ADDENDUM #1

TO CONTRACT DOCUMENTS FOR: Project # CP242862-PICKARD HALL-PHASE 1-
SELECTIVE DEMOLITION AND RAD CHARACTERIZATION

PREPARED FOR: The Curators of the University of Missouri

FA103

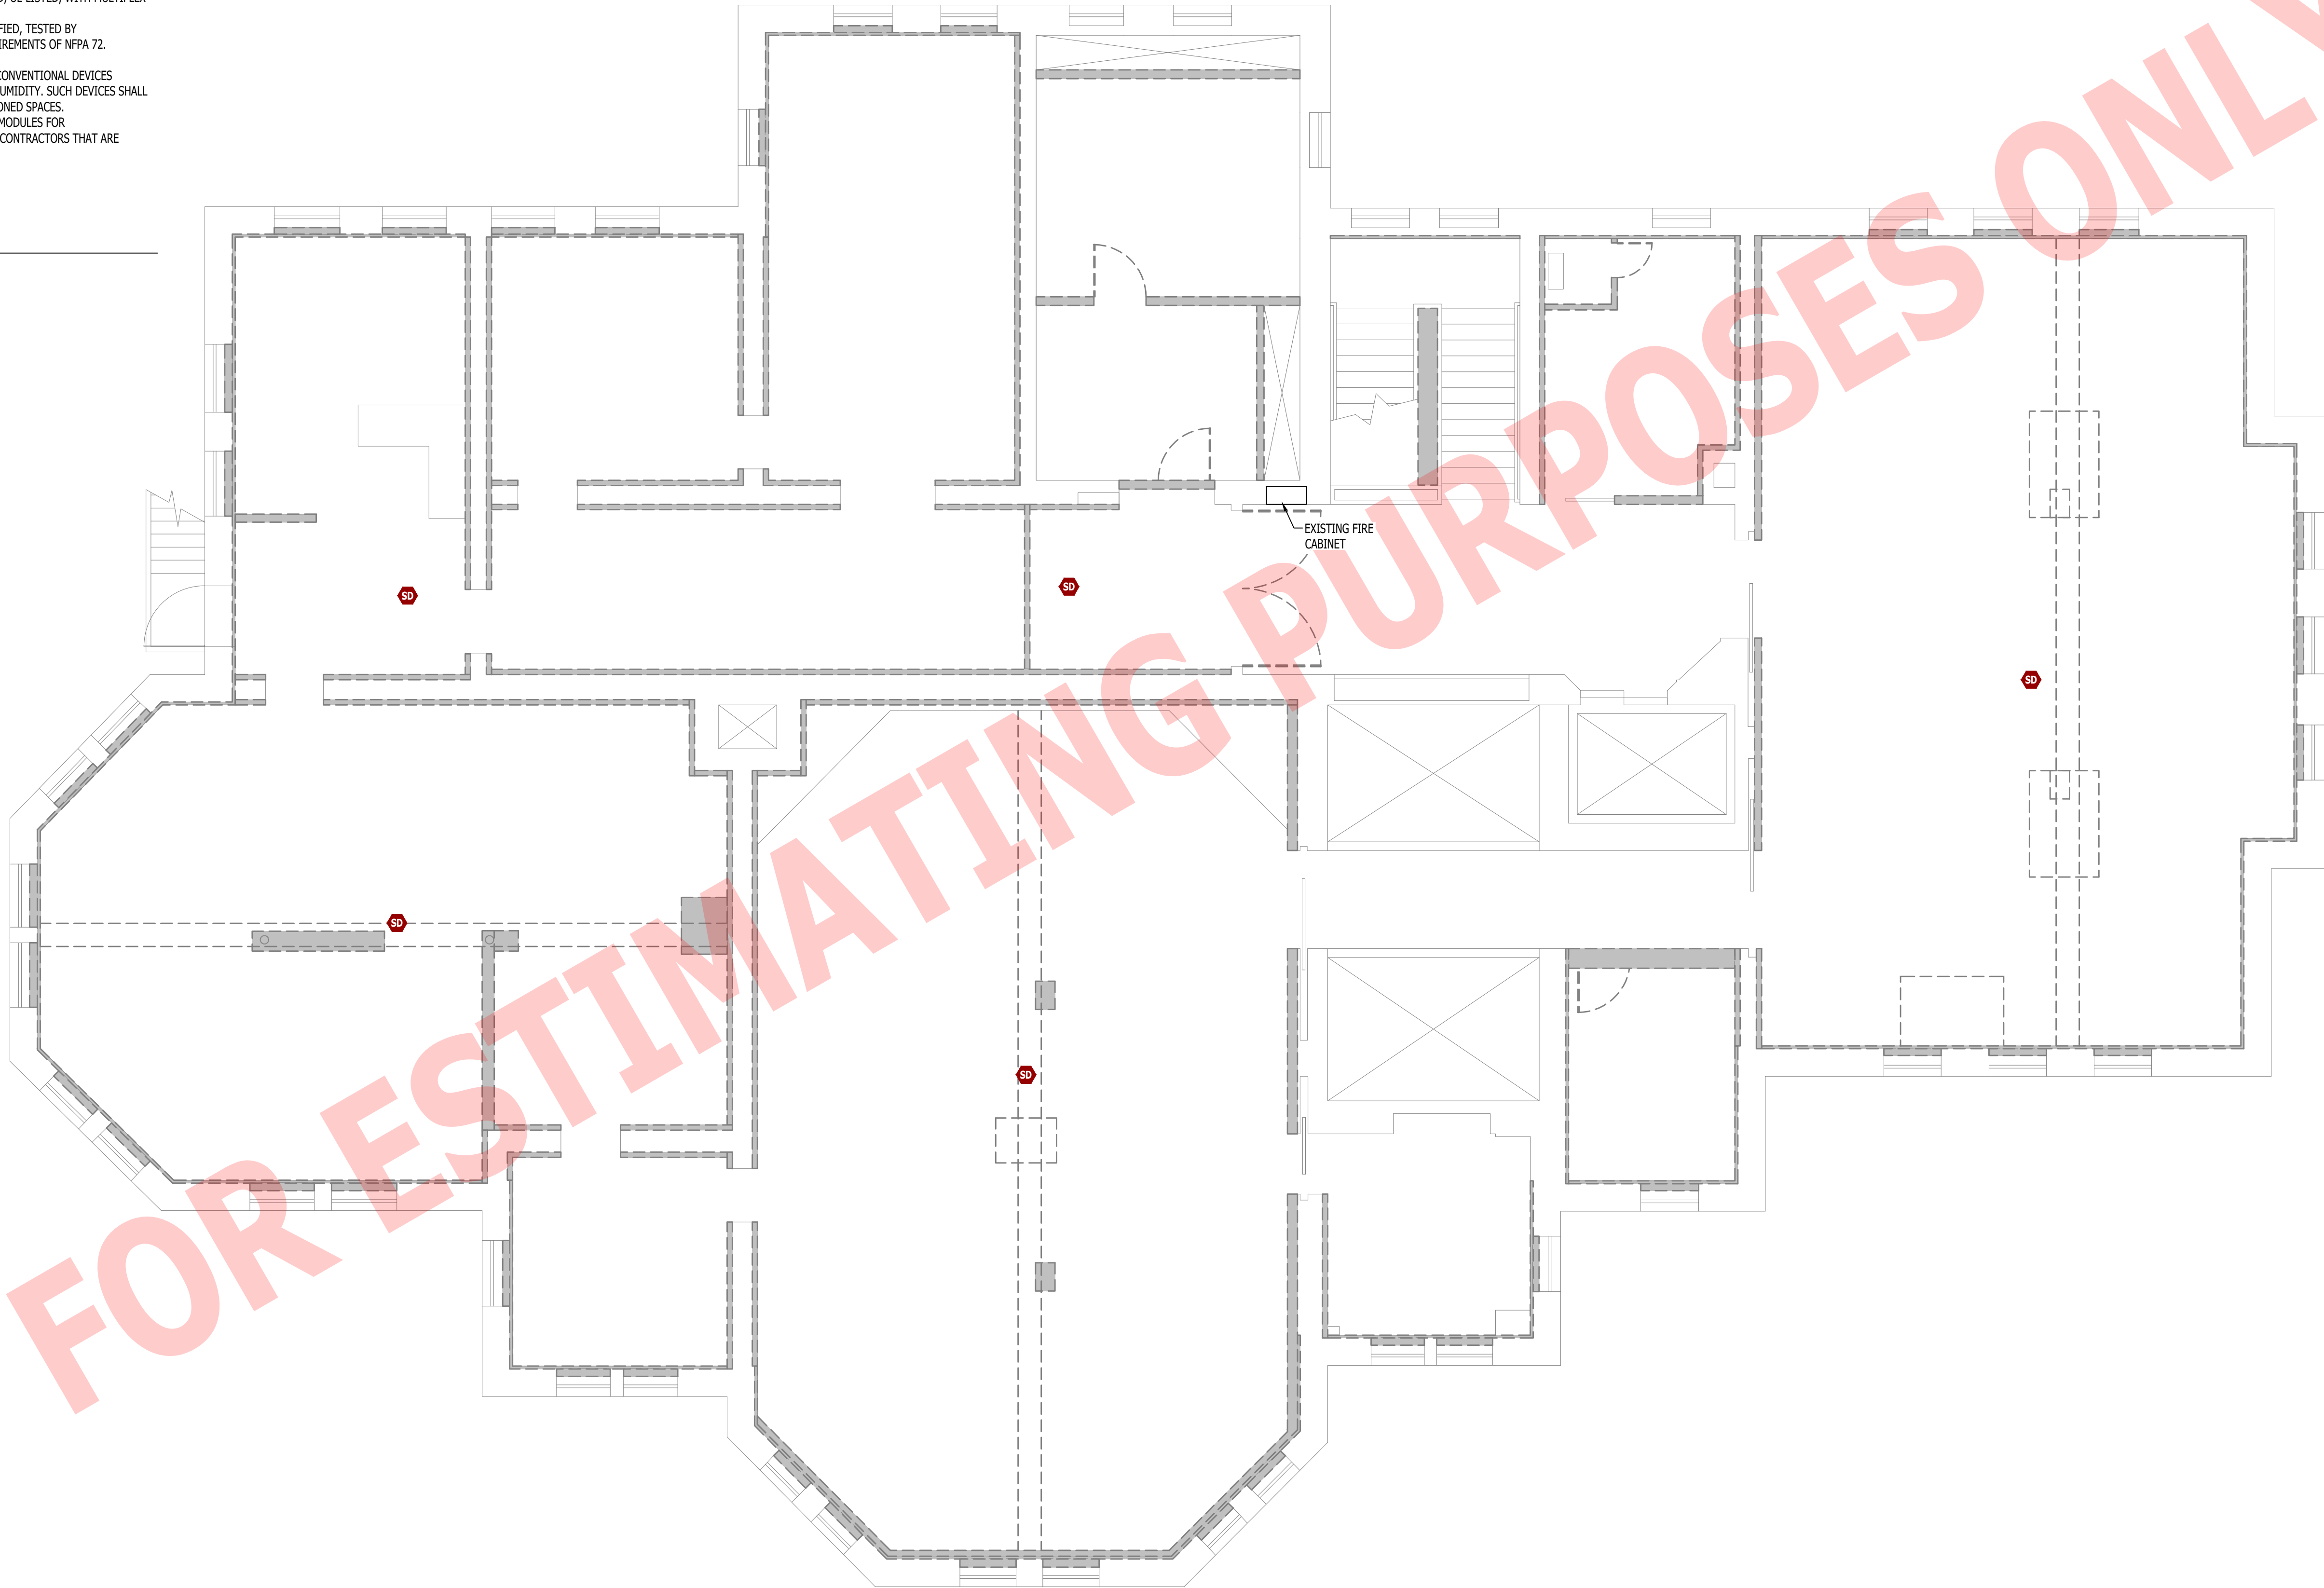
3. On Drawing sheet FA101 through FA103, fire alarm specification notes #6. No wireless systems will be allowed.
4. On Drawing sheet FA102. Added a manual pull station for the fire alarm system.

1. FIRE ALARM SYSTEM SHALL BE AN ADDRESSABLE SYSTEM THAT IS NONCODED, UL-LISTED, WITH MULTIPLEX SIGNAL TRANSMISSION AND HORN/STROBE EVACUATION.
2. EVERY FIRE ALARM SYSTEM COMPONENT SHALL BE UL-LISTED AND UL-CERTIFIED, TESTED BY MANUFACTURERS AS A COMPLETE SYSTEM, AND MEET ALL APPLICABLE REQUIREMENTS OF NFPA 72.
3. ALL FIRE ALARM WIRING TO BE PLENUM RATED.
4. ALL INITIATING DEVICES INSTALLED IN UNCONDITIONED SPACES SHALL BE CONVENTIONAL DEVICES SUITABLE FOR USE IN EXTREME HIGH AND LOW TEMPERATURES AND HIGH HUMIDITY. SUCH DEVICES SHALL BE SUPERVISED BY ADDRESSABLE MONITOR MODULES LOCATED IN CONDITIONED SPACES.
5. QUANTITIES, TYPES, AND LOCATIONS OF INITIATING DEVICES AND OUTPUT MODULES FOR INTERCONNECTION WITH FIRE SUPPRESSION MUST BE COORDINATED WITH CONTRACTORS THAT ARE RESPONSIBLE FOR THOSE SYSTEMS.
6. NO WIRELESS SYSTEMS WILL BE ALLOWED.
